ACCELERATED DISTRIBUTION DEMONSTRATION SYSTEM

SUBJECT: Forwards responses to questions re restart action plan (RAP) & nuclear improvement plan along w/RAP replacement pages.

Re: Nine Mile Point Unit 1
Docket No. 50-220 DPR-63

NRC Concerns and Questions on the Nine Mile
Point Unit 1 Restart Action Plan
and
Niagara Mohawk's Responses

FIGURE 1 - 1
 (Reference RAP Question 1)
 Savannah River Reactor Incident Root
 Cause Coding Tree

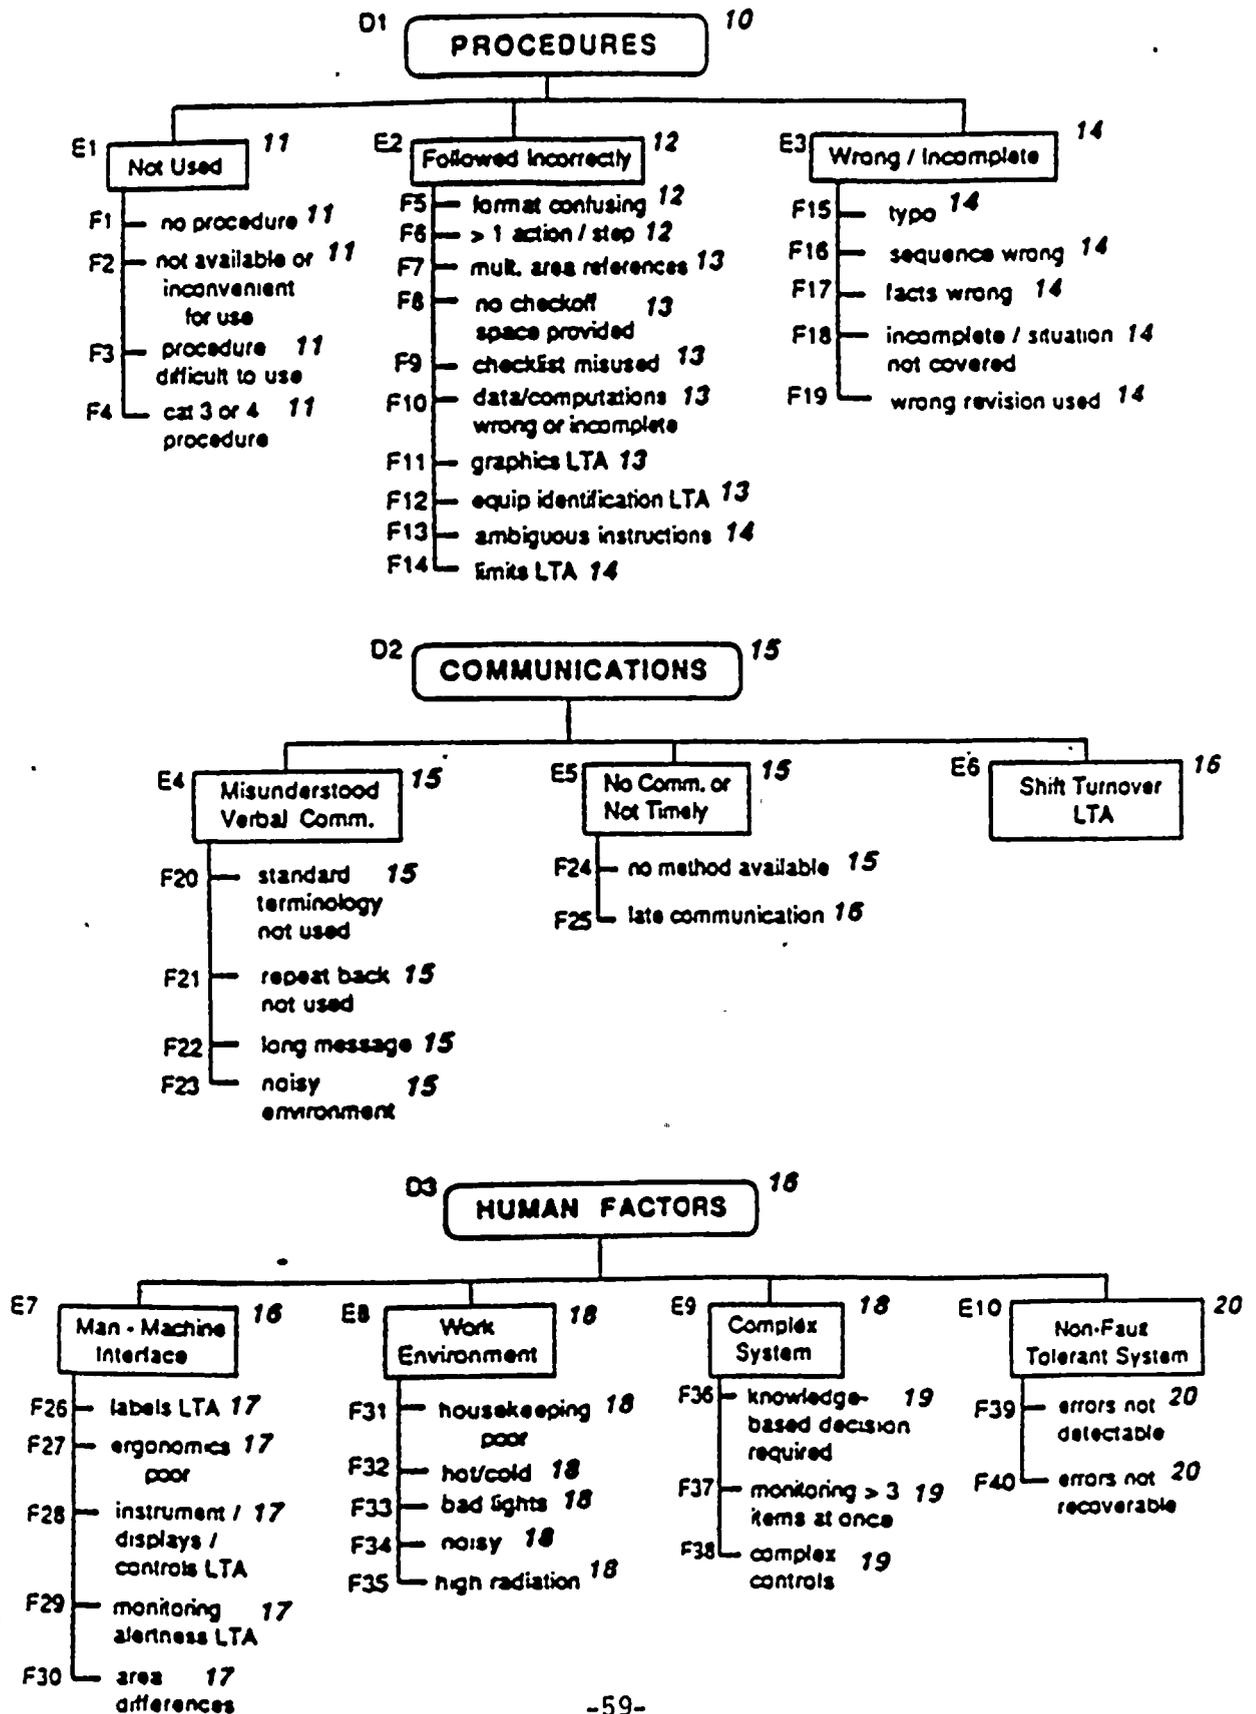
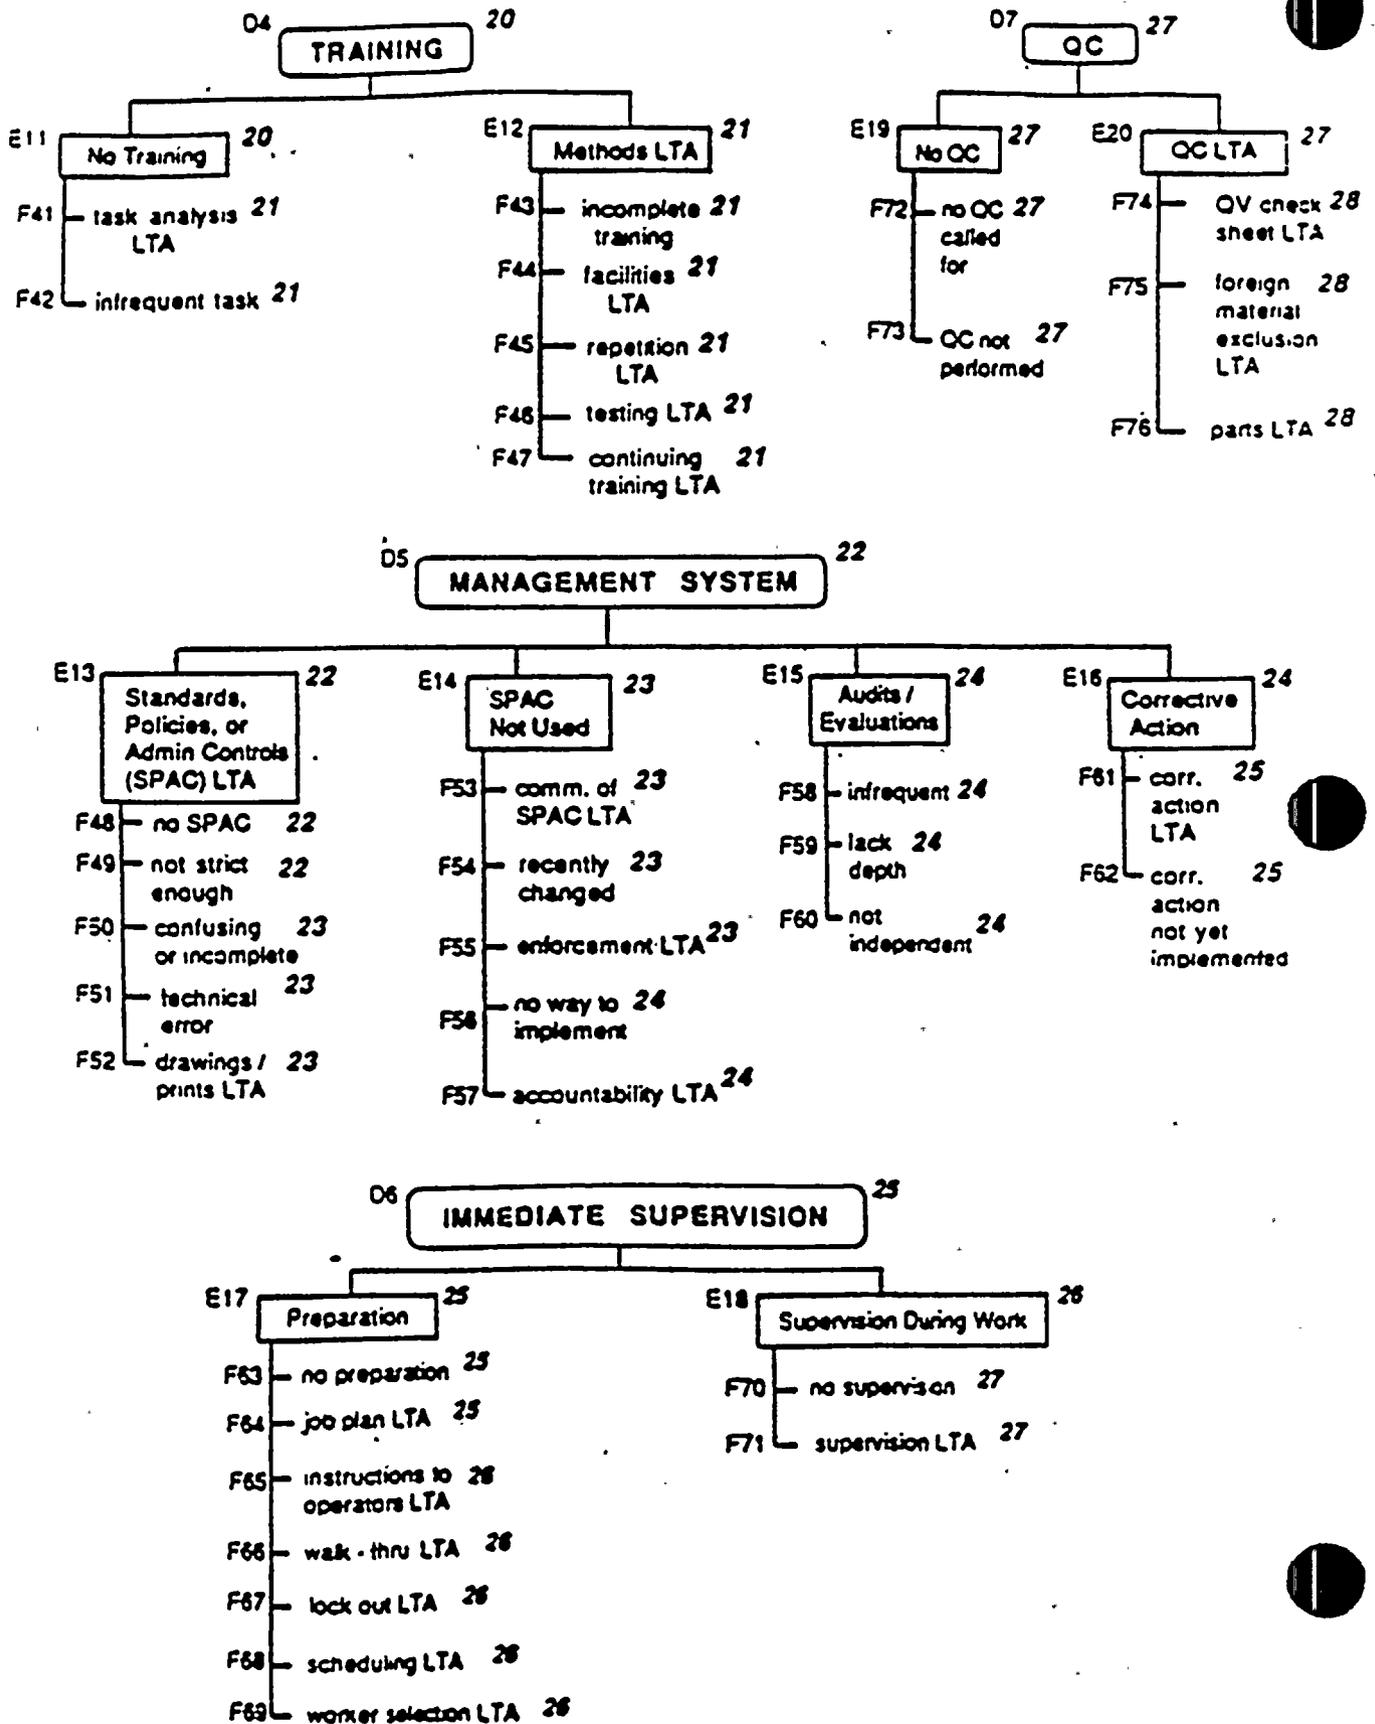
1. The Panel had difficulty in understanding the logic used to determine the underlying root causes outlined in Table 1, Page B-3 of the RAP. In particular, the correlation between all of the Savannah River (SR) Causal Trees used and the final underlying root causes of Management and Organizational Effectiveness outlined in Figure 1, Page B-4 of the RAP is confusing. It is not clear how the transition was made from use of the Savannah River Causal Trees to the NMPC Management and Organizational Effectiveness Cause Tree. For example, why the quality assurance section was deleted, and what was done with the 25% of the root causes not attributed to management and supervision (Pg. B-1) are not clear. Please explain.

The initial assessment of various deficiencies, including the Specific Issues, for their common causes of concerns/problems involved using the Savannah River Reactor Incident Root Cause Coding Tree containing seven branches, D1-D7 (See Figure 1-1). The Restart Action Plan has been clarified to show this specific information. Approximately 75% of the causes were attributed to the Management Systems D5 branch and the Immediate Supervision D6 branch. The remaining 25% of the causes were attributed to Procedures, Communication, Human Factors, and Training (D1-D4). The QC branch D7 was not determined to be the cause for any of the identified deficiencies.

The Restart Action Plan Appendix B has been revised to reflect this clarification.

FIGURE 6-1

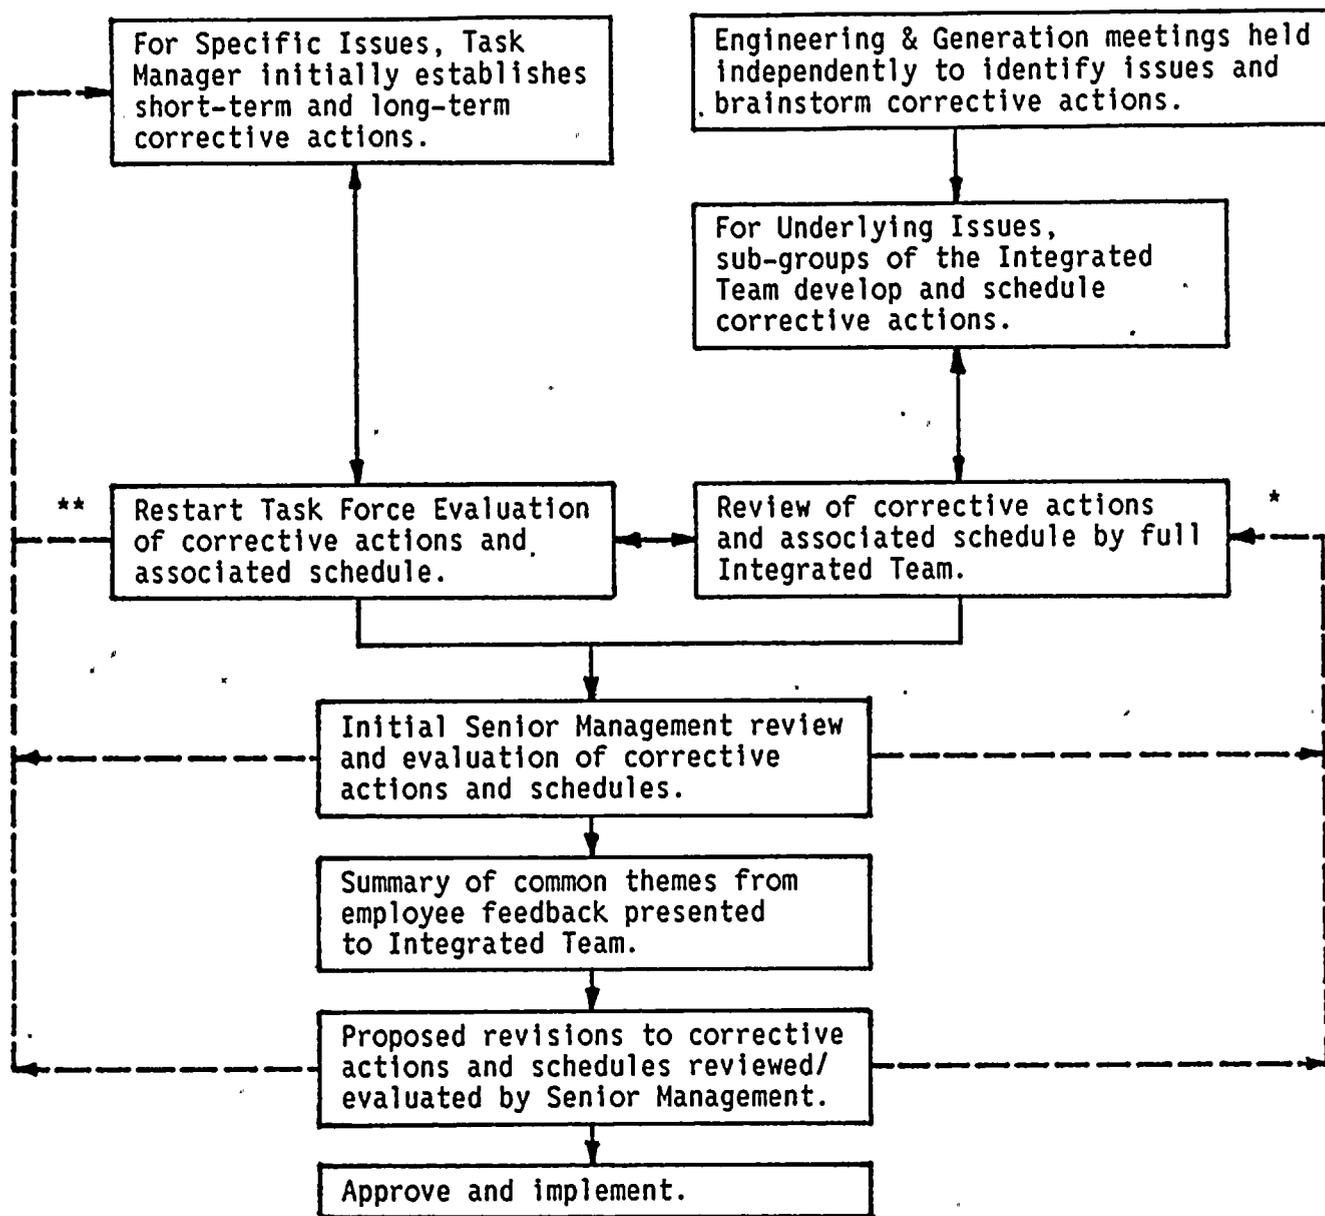
5. The Restart Action Plan (RAP) does not adequately address the last sentence of item 2 in CAL 88-17. "For actions proposed for completion after restart, you will provide justification for why completion after restart will not have an adverse impact on safe plant operation." The criteria or process the licensee used to determine which items could affect safe operations (and therefore should be completed prior to restart) was not sufficient for the NRC to understand and therefore judge acceptability. Please provide an explanation of the criteria or methods used to determine potential impact on safe plant operation.

6. The Plan does not address a schedule for completion of items after startup as committed to in item 2 of the CAL. Adequate justification was not documented for deferral to post restart or long term strategies. Please provide the deferral justification in a revision to the RAP and provide a schedule for implementation of those long term strategies that address the underlying root causes of management ineffectiveness.

RESPONSE TO QUESTIONS 5 AND 6:

Each corrective action was evaluated to determine its significance to safe plant operation or its necessity to demonstrate sufficient progress on resolution of the issues that will not be fully resolved before restart. The prioritization of corrective actions can be characterized as follows:

The Executive Summary of the Restart Action Plan has been revised to clarify the criteria used to classify items as Priority 1, 2, or 3. A new Appendix C has been included in the Restart Action Plan to address the process for prioritizing corrective actions.
